# Engineering Change Notification

## Setting interface for End stop / Cushioning changes from hexagonal socket to external hexagon

**Project No**  
243216

**Project Title**  
DGC End stop change

#### Previous Version

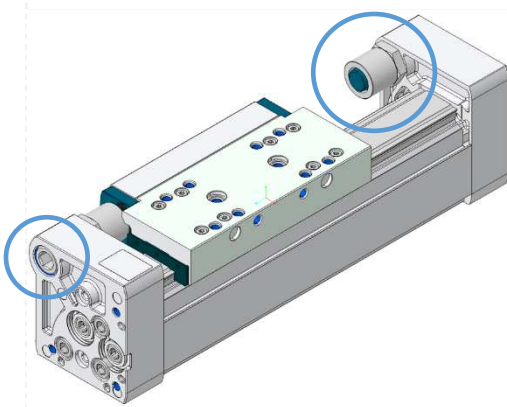
Hexagonal socket  
for setting interface of end stop

#### Future Version

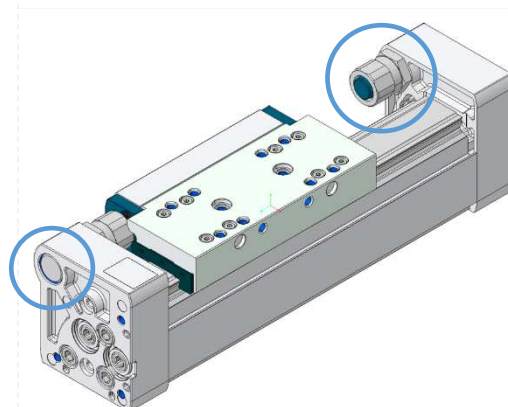
With this change the setting interface of the End stop / Cushioning changes from hexagonal socket to external hexagon.

External hexagon  
for setting interface of end stop
